STAFF REPORT FOR THE PLANNING COMMISSION

FILE NUMBER: SUB-18-02

REQUEST: 4-lot Subdivision at 19310 Suncrest Drive

SHEET NUMBER
C210

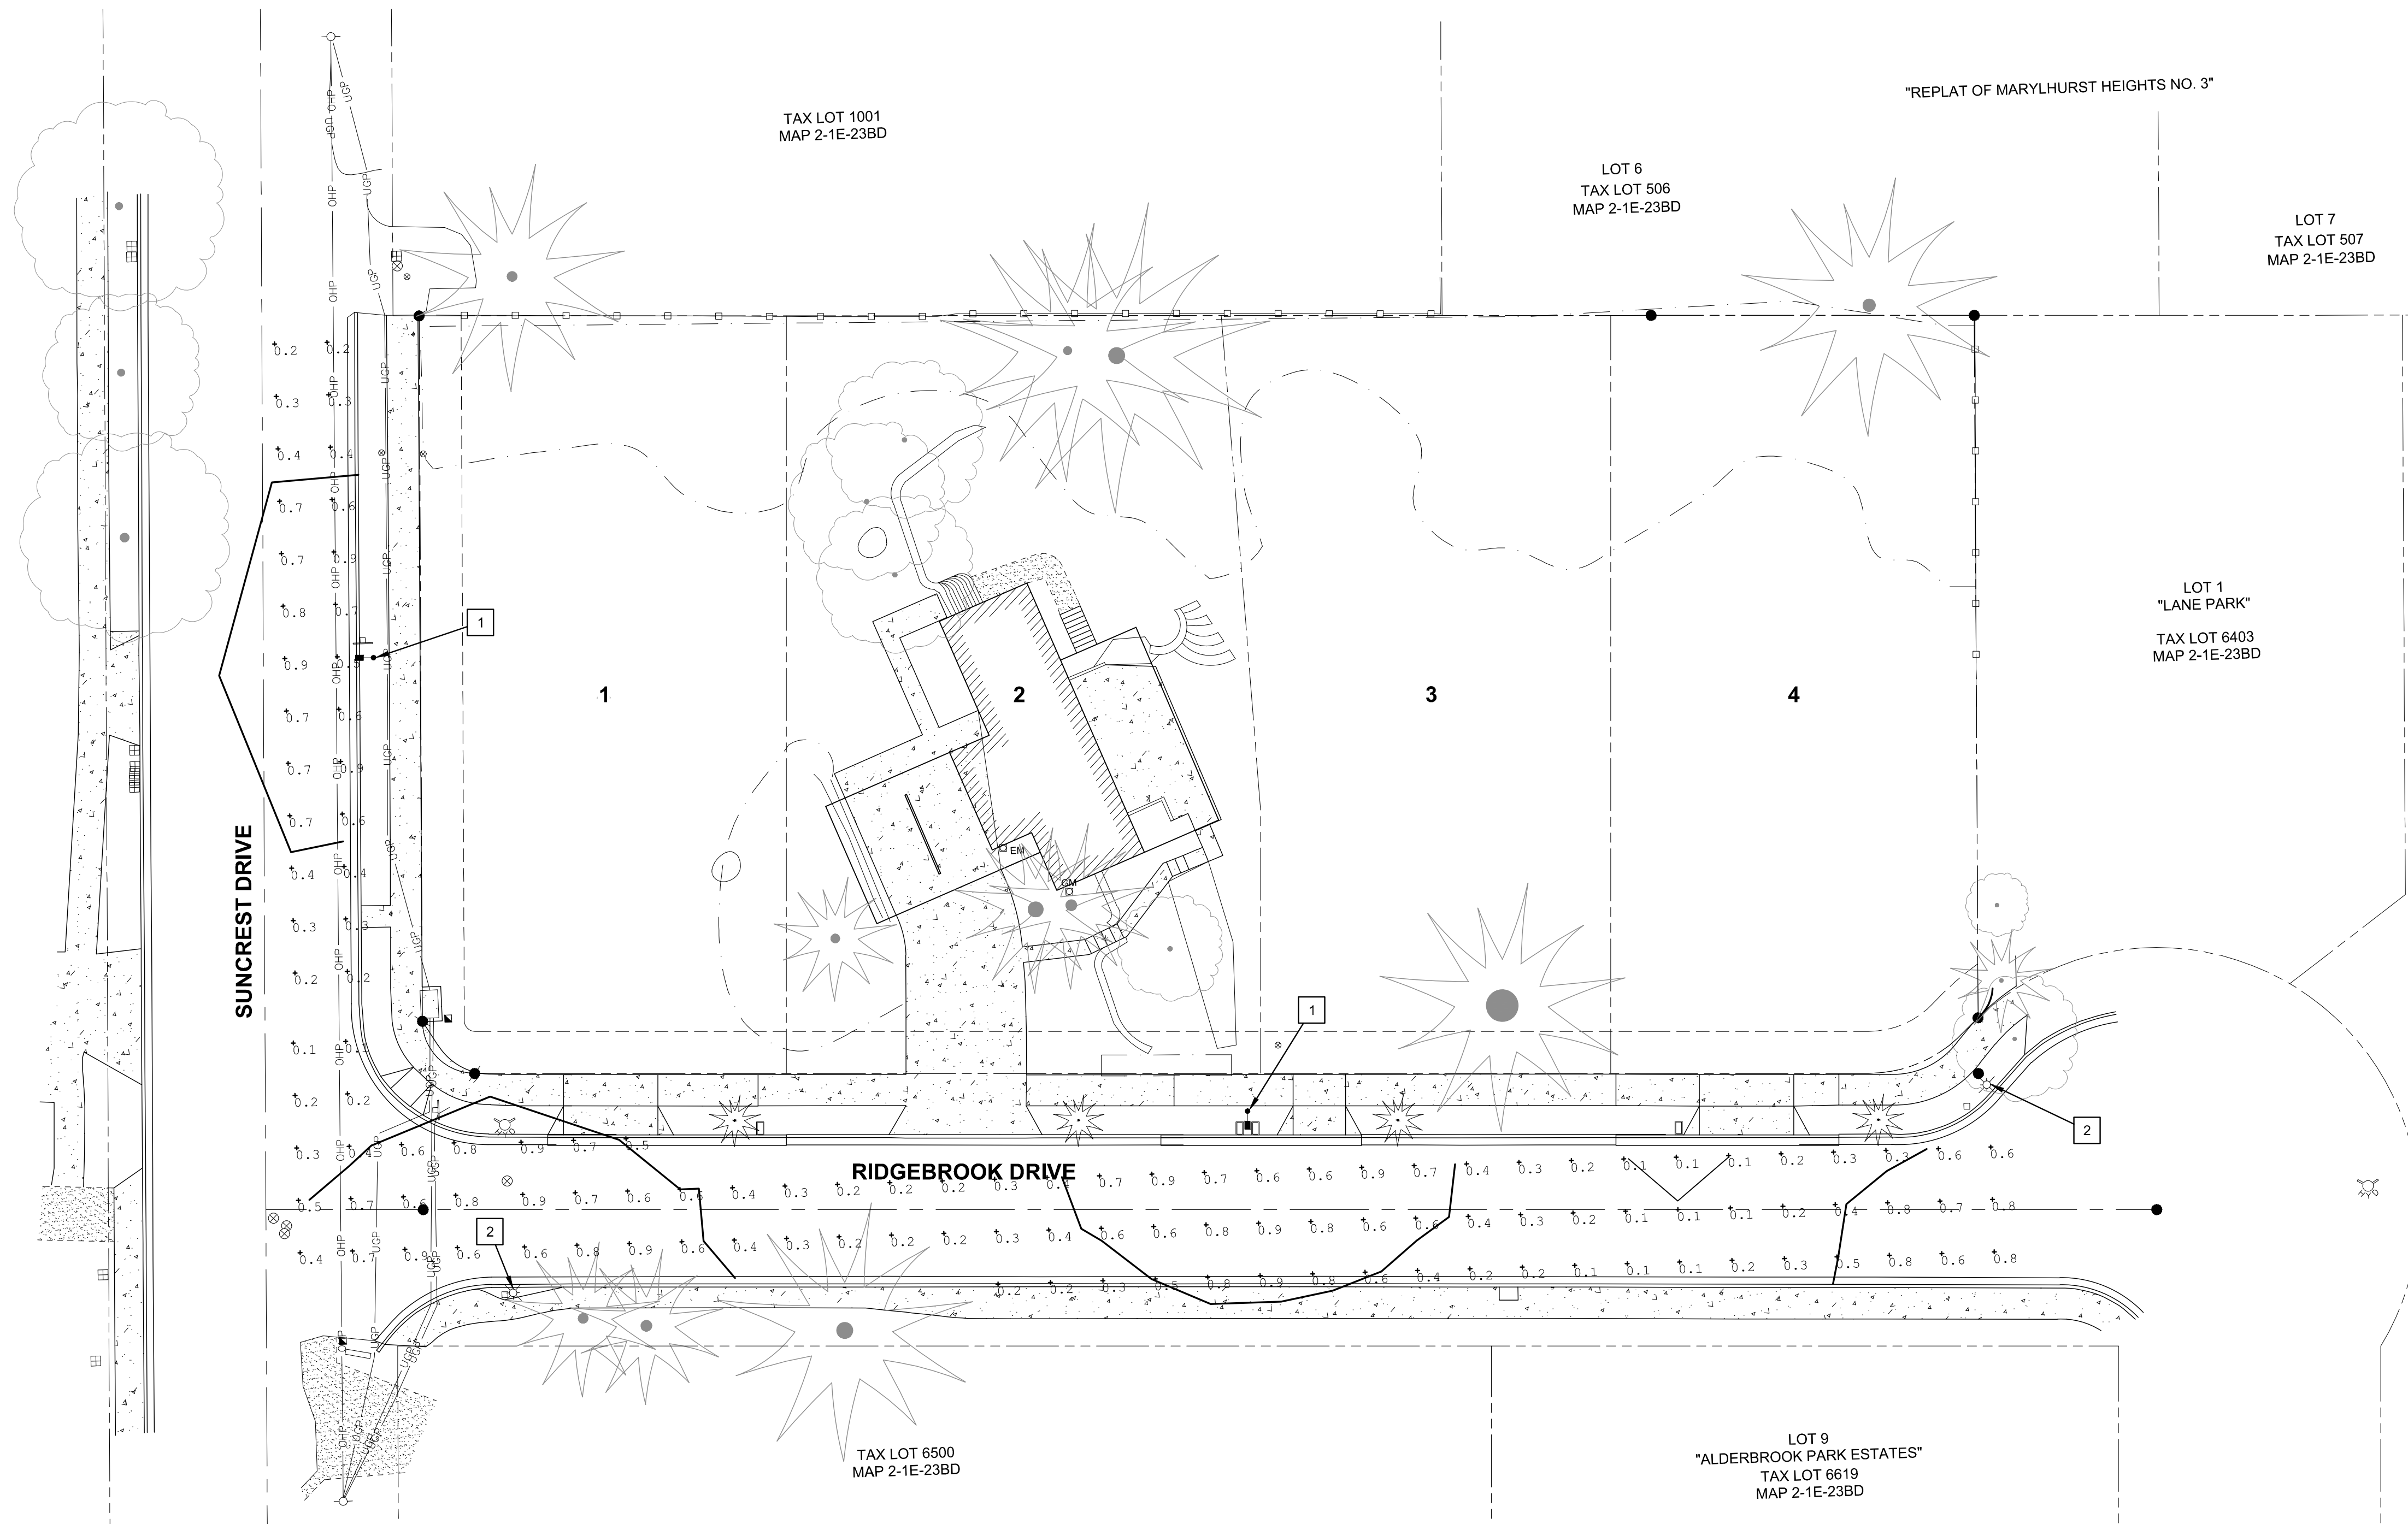
Staff Finding 13: All driveways and curb cuts shall meet the engineering standards of Condition of Approval number 2. The applicant proposes 18 feet curb cuts for proposed lots 1 and 4 via Ridgebrook Drive, the proposed curb cut for proposed lot 3 is 10 feet due to a significant tree, and lot 2 will use the existing driveway access (see applicant's submittal Sheet C210). These criteria are met.

Staff Finding 27: The TSP does not identify Suncrest Drive or Ridgebrook Drive in the Bike Plan (See Figures 5-1 and 6-2 of the TSP), but does include Suncrest Drive as a low priority in the Pedestrian Plan for sidewalks on one side. The applicant proposes to maintain the existing sidewalk along the frontage of the subject property on Suncrest Drive (see sheet C210 of the applicant's submittal. The criteria is met.

UTILITY PLAN
SUNCREST SUBDIVISION
19310 SUNCREST DRIVE
KATHLEEN DAILEY
WEST LINN, OREGON

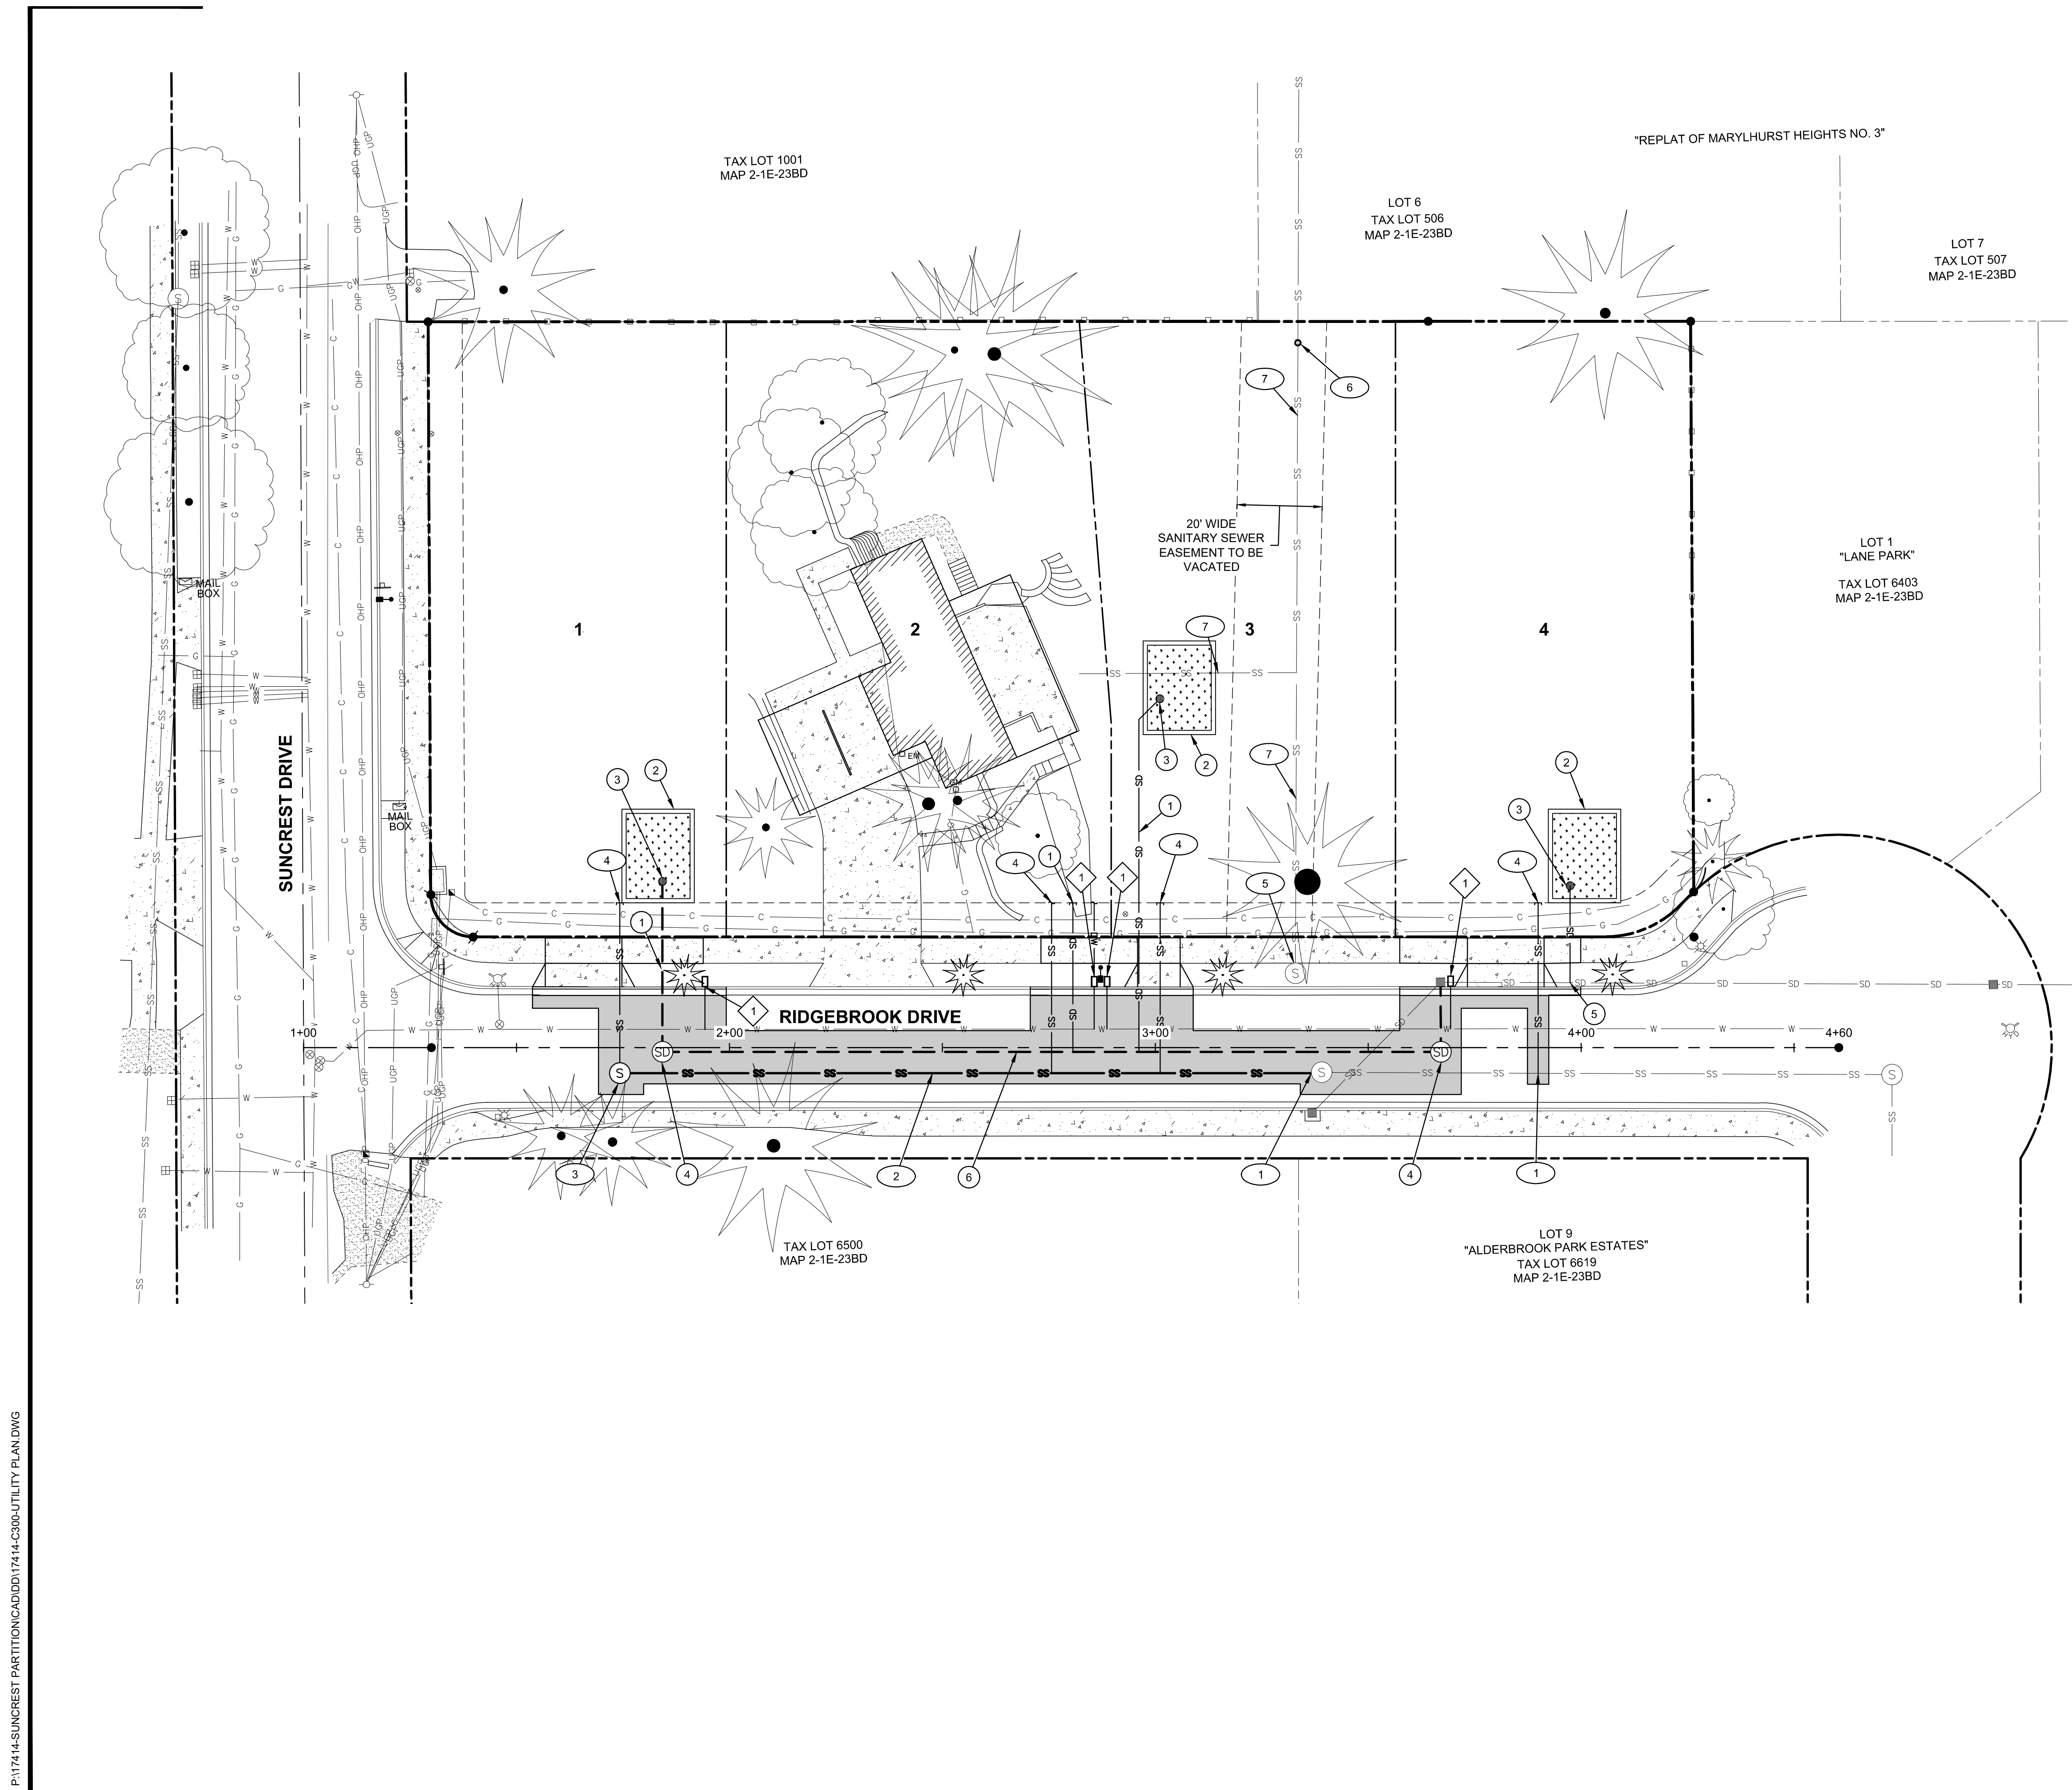
Staff Finding 29: The existing home on proposed lot 2 currently has water service via Suncrest Drive. The applicant proposes replacing the water service for proposed lot 2. Following the subdivision, the applicant proposes to extend water service for all lots via RidgeBrook Drive (see 'Utility Plan' sheet C300 of the applicant's submittal). The criteria is met.

sewer connections via a sewer lateral in proposed lot 3. Per condition of approval 3, the applicant proposes to abandon the existing sewer lateral at an upstream location and vacate the existing sewer easement. All four lots will have a new sewer lateral via the extended sewer line in Ridgebrook Drive. The extension shall be reviewed and approved by the City Engineer per condition of approval 2. The sewer extension is the responsibility of the applicant per condition of approval 2 (see 'Utility Plan' sheet C300 of the applicant's submittal). Subject to conditions of approval, the criteria is met.
